# Market Landing Park Expansion Onyx Corporation Project Logistics

# Central Waterfront Parking after "Phase 1A" Park Construction

# TEMP PARKING STUDY - MAXIMIZED

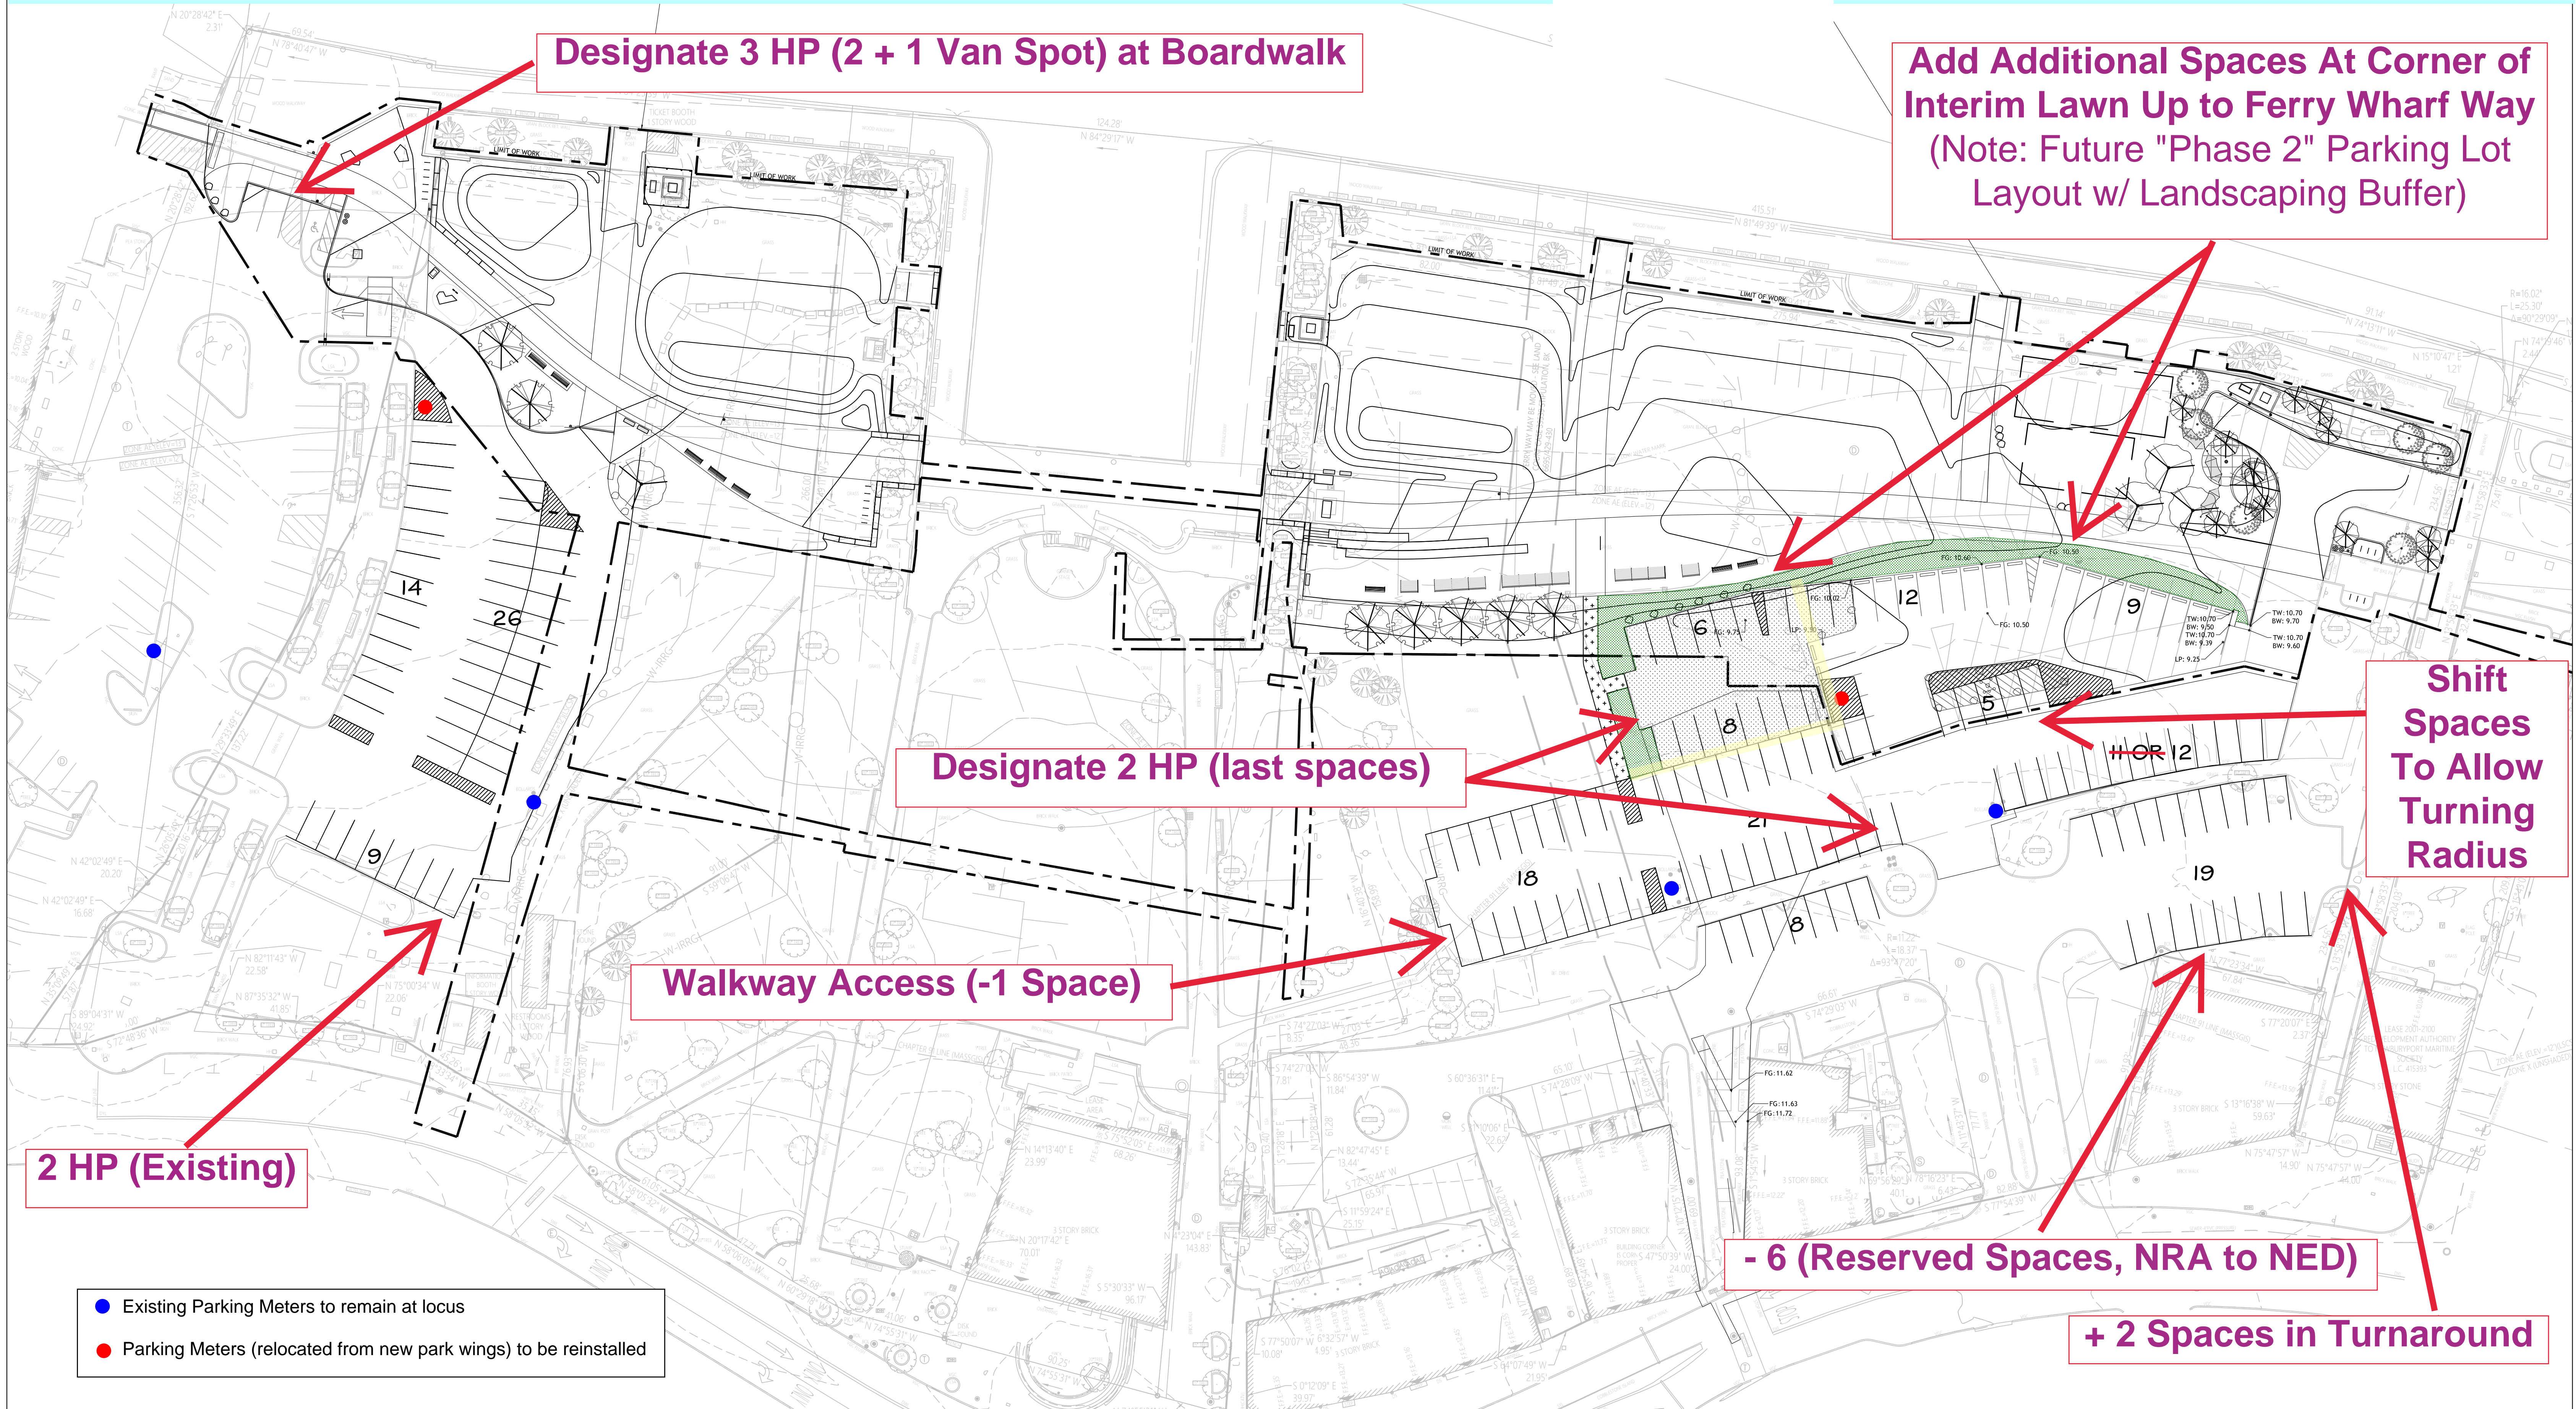
**Sasaki to Reconfigure "Remaining" NRA East & West Lots to Provide the Maximum Feasible Number of Public Parking Spaces During the Interim Period Between "Phase 1A" and Remaining Project Phases**

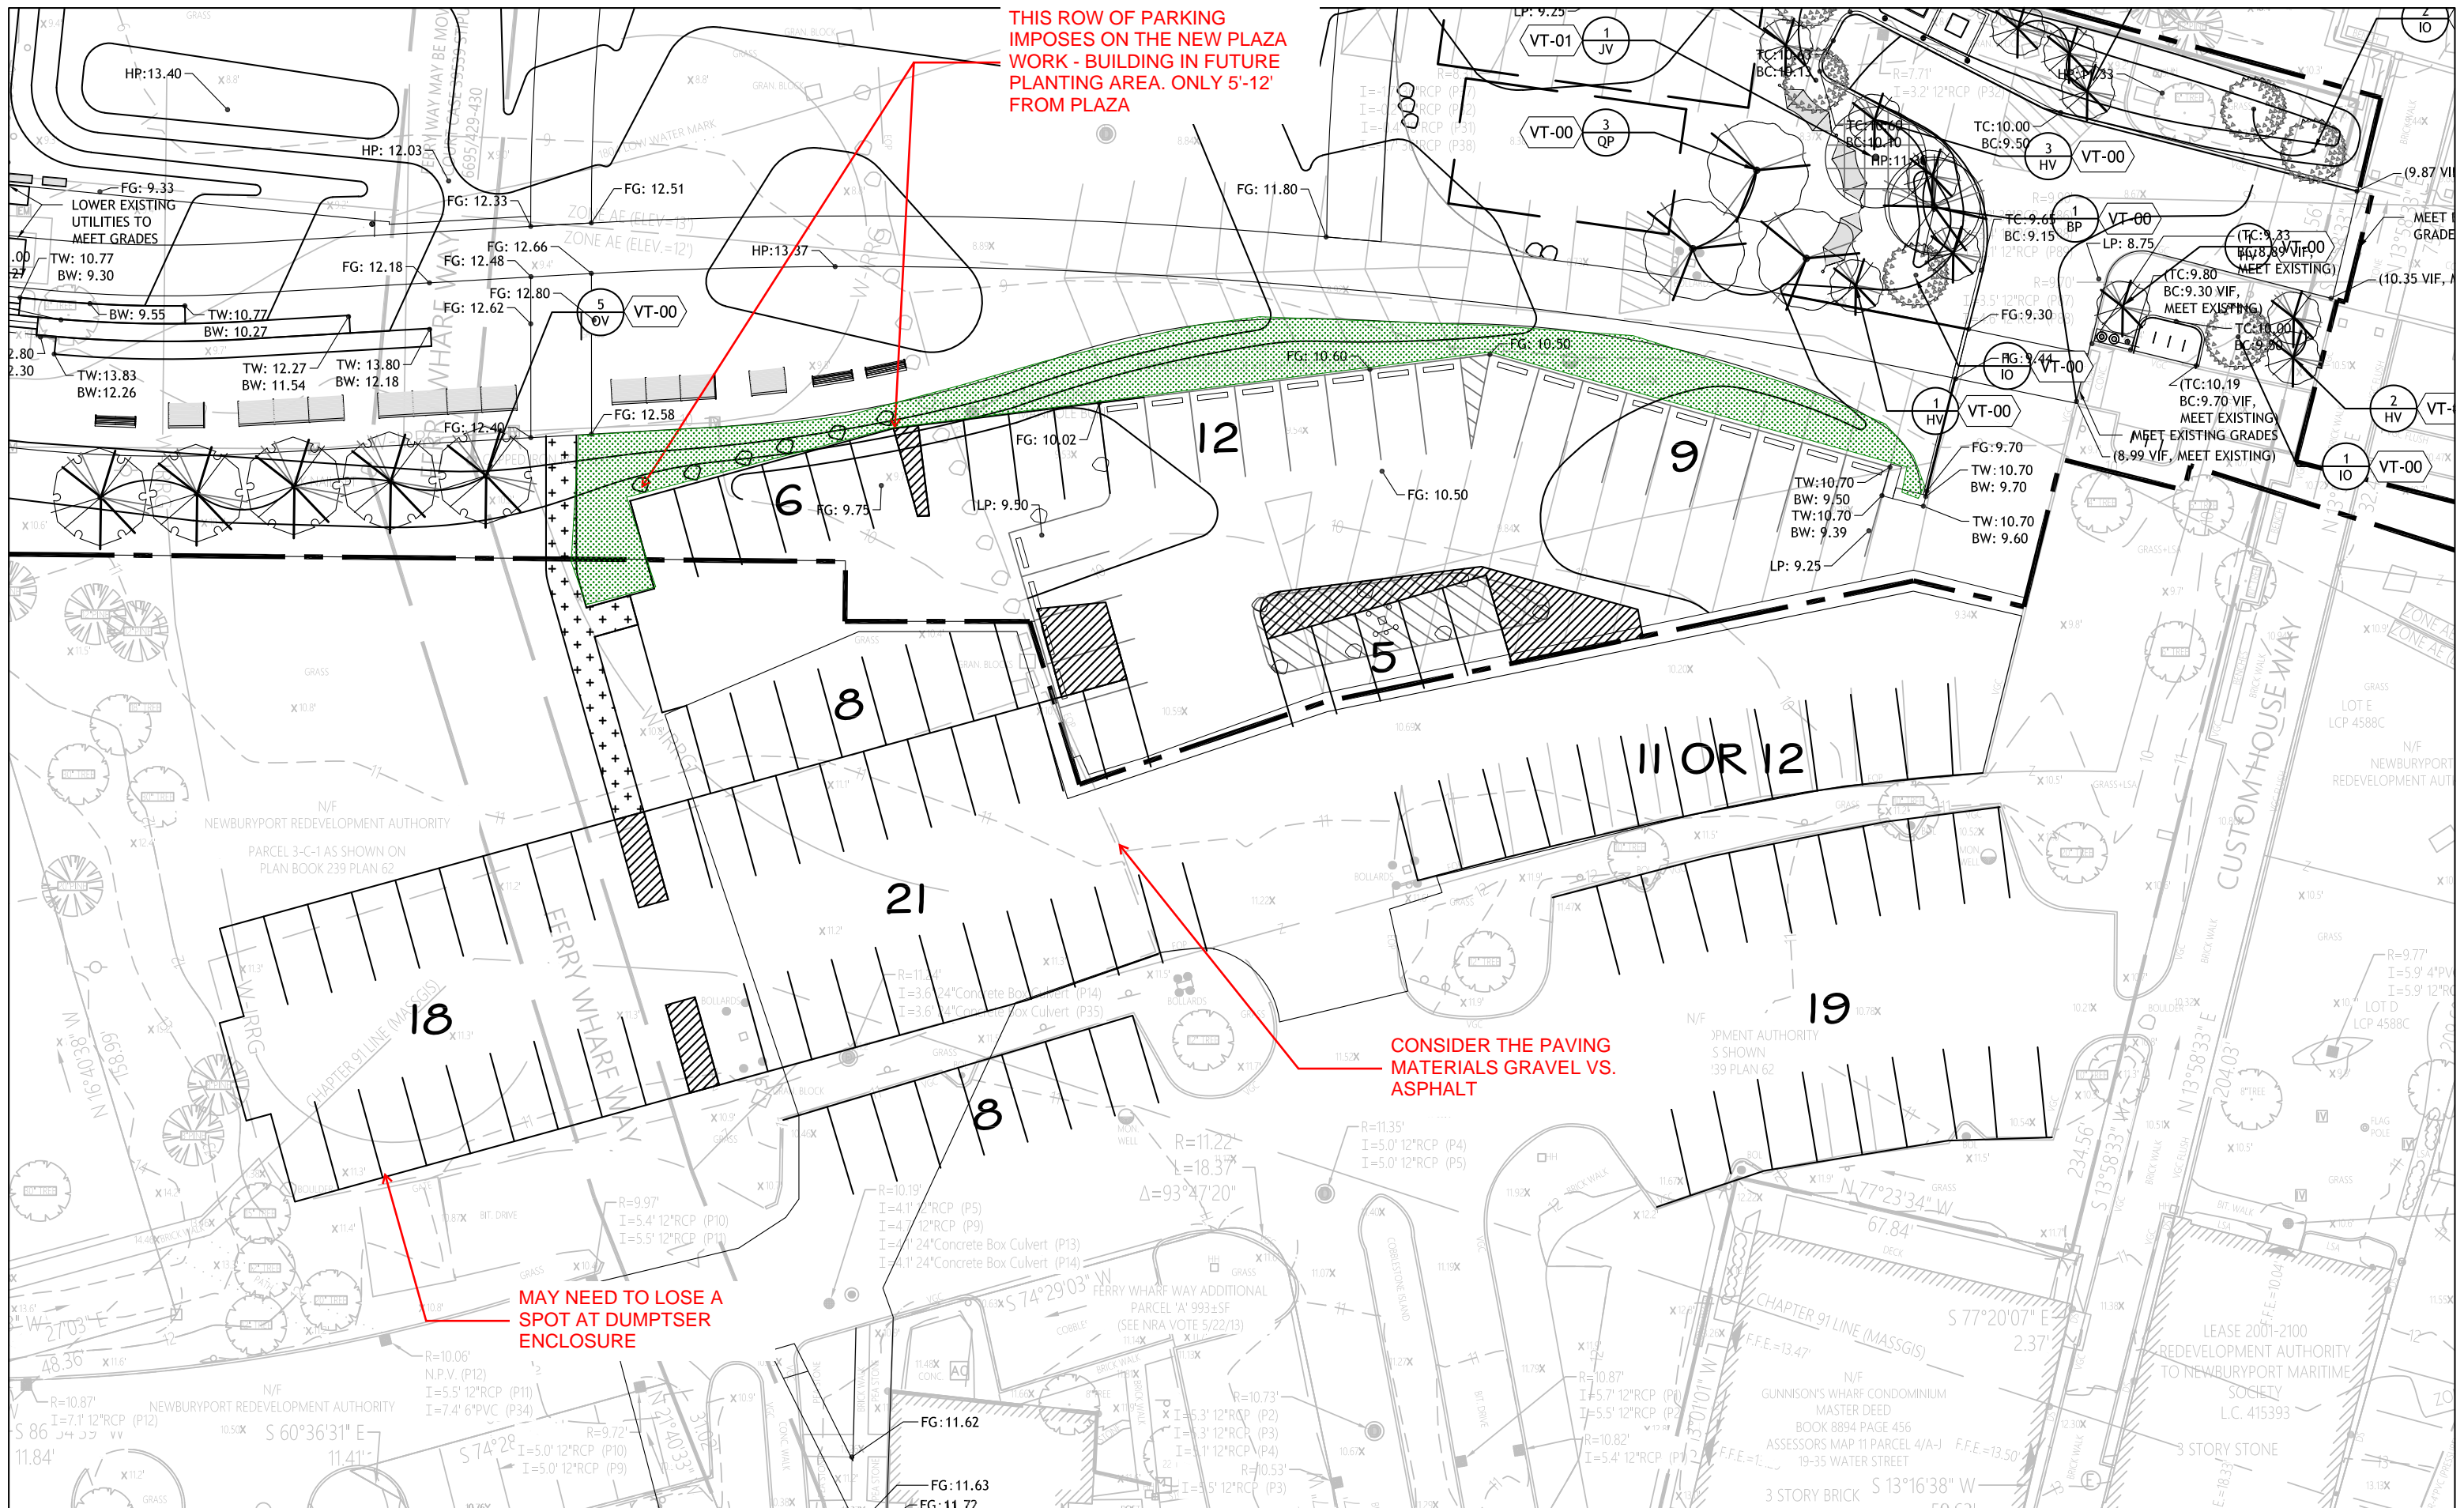
THIS ROW OF PARKING IMPOSES ON THE NEW PLAZA WORK - BUILDING IN FUTURE PLANTING AREA. ONLY 5'-12' FROM PLAZA

CONSIDER THE PAVING MATERIALS GRAVEL VS. ASPHALT

MAY NEED TO LOSE A SPOT AT DUMPTSER ENCLOSURE
